<b>AMENDMENT OF SOLICITATION/MODIFICATION OF CONTRACT</b>			1. CONTRACT ID CODE	PAGE OF PAGES 1   8
2. AMENDMENT/MODIFICATION NO. <b>0003</b>	3. EFFECTIVE DATE 10-May-2009	4. REQUISITION/PURCHASE REQ. NO.		5. PROJECT NO.(If applicable)

14. DESCRIPTION OF AMENDMENT/MODIFICATION (Organized by UCF section headings, including solicitation/contract subject matter where feasible.)  The purpose of this Amendment is to provide contractors with the answers, where appropriate, to questions submitted by contractors, and to make minor changes to Section 01015 Technical Requirements. See the Summary of Changes page for details. The Proposal due date remains unchanged.				
Except as provided herein, all terms and conditions of the document referenced in Item 9A or 10A, as heretofore changed, remains unchanged and in full force and effect.				
15A. NAME AND TITLE OF SIGNER (Type or print)		16A. NAME AND TITLE OF CONTRACTING OFFICER (Type or print)		
		TEL:	EMAIL:	
15B. CONTRACTOR/OFFEROR	15C. DATE SIGNED	16B. UNITED STATES OF AMERICA		16C. DATE SIGNED
_____ (Signature of person authorized to sign)		BY _____ (Signature of Contracting Officer)

### CONTRACTOR QUESTIONS ANSWERED

Figure 2-4—Primary loop system

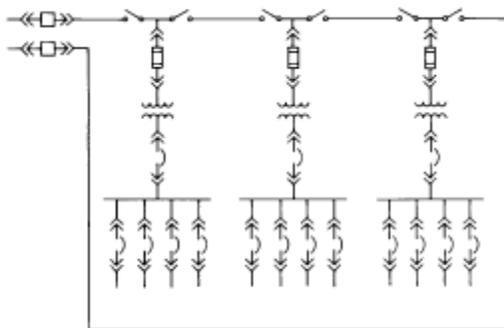
2. What is the intent for each of the (3) 15 kV feeder breakers? Our understanding is (2) of the 15 kV feeder breakers would feed a primary loop system. Is the loop intended to be open or closed? Will the third 15 kV feeder breaker be dedicated to the inter-tie between the two power plants?

***Answer #2: There shall be three 15kV feeders supplying power to the installation from the power plant. Each feeder shall have a breaker. The ends of the feeders shall be tied together with a switch so that they can be tied together.***
